# United States Patent and Trademark Office

This is an office action for serial number 10/768,406, entitled Serving Terminal Illuminator, filed on January 30, 2004.

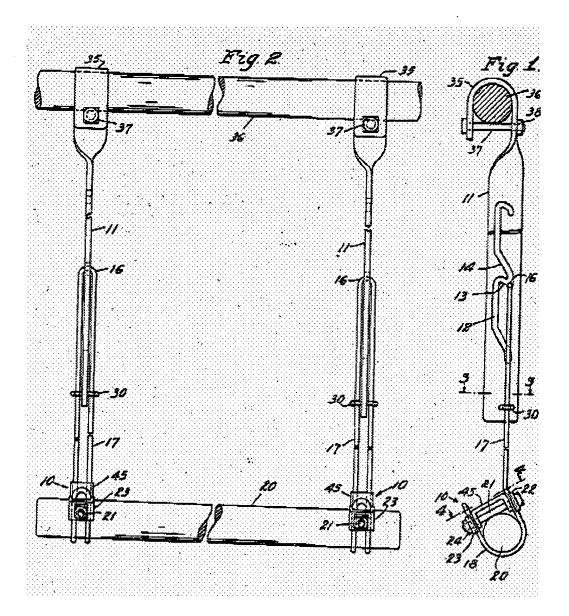
Claims 17 and 19 are rejected under 35 U.S.C. 103(a) as being unpatentable over Witter 2,193,215. Witter discloses a hanging tool support assembly comprising a pair of inverted, parallel J-shaped hangers (figure 2) comprising a front and rear hanger (left and right hanger); the front hanger having a top portion (below 37), a vertically adjustable middle portion (near 16), and a bottom portion (below 17); the rear hanger comprises a top portion and a movable bottom portion; a tool support base plate (45), a means to secure (21 and 18), an attachment means (37).

Witter discloses all of the limitations of the claimed invention except for the base plate attached to the bottom portion the front hanger and to the bottom portion of the rear hanger.

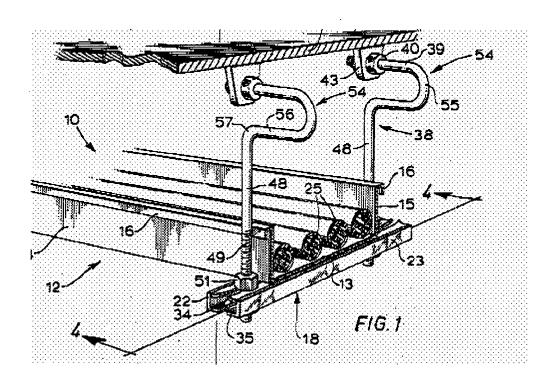
Tardoskegyi teaches that it is known to have a hanging tool support assembly comprising a pair of inverted, parallel U-shaped hangers (54) comprising a front and rear hanger (left hanger and right hanger); each hanger having a free end and a

downwardly extending arm wherein the front hanger having a top portion (between 57 and 48), a vertically adjustable middle portion (51 being female cylinder and threaded portion is the male shaft), and a bottom portion (52); the rear hanger comprises a top portion (between 57 and 48) and a movable bottom portion (52); a tool support base plate (18), a means to secure (15), an attachment means (40).

It would have been obvious to one having ordinary skill in the art to have modified Witter to have included the base plate attached to the bottom portion of the front hanger and the moveable bottom portion of the rear hanger as taught by Targoskegyi for the purpose of reducing the number of parts

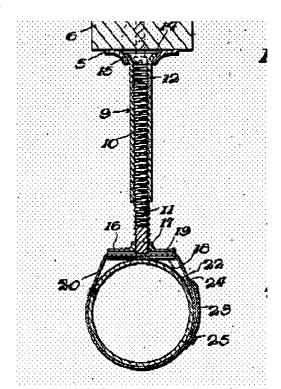
Claim 18 is rejected under 35 U.S.C. 103(a) as being unpatentable over Witter in view of Targoskegyi in further view of Flower 2,161,782. Flower discloses a downwardly extending arm comprising a top portion (5), a vertically adjustable middle portion having a female cylinder (10) and a male shaft (11), wherein the female cylinder attaches to the top portion and the male shaft attaches to the bottom portion, and a bottom portion (near 17).

It would have been obvious to one having ordinary skill in the art to have modified Witter in view of Targoskegyi the female cylinder attaches to the top portion and the male shaft attaches to the bottom portion as taught by Flower for the purpose of facilitating adjustment of the length of the hanger.

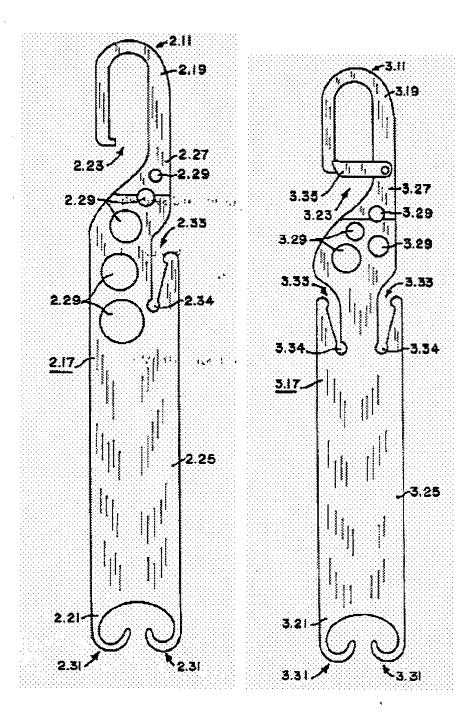
Claims 20 and 21 are rejected under 35 U.S.C. 103(a) as being unpatentable over Witter in view of Tagoskegyi in further view of Atchley et al. (Atchley) 2003/0025056A1. Witter in view of Tagoskegyi disclose all of the limitations of the claimed invention except for the attachment means being a lever and a lip wherein the lever attaches to an inner portion of the free end and a lip attaches to an inner portion of the downwardly

extending end. Atchley teaches that it is known to have a lever (3.35) with a joint and lip (near 2.23).

It would have been obvious to one having ordinary skill in the art to have modified Witter in view of Tagoskegyi to have included the hook as taught by Atchley for the purpose of facilitating removal and attachment of the hanger on the support line. It would have been obvious to one having ordinary skill in the art at the time the invention was made to have the lever and the lip wherein the lever attaches to an inner portion of the free end and a lip attaches to an inner portion of the downwardly extending end, since it has been held that a mere reversal of the essential working parts of a device involves only routine skill in the art. In re Einstein, 8 USPQ 167.
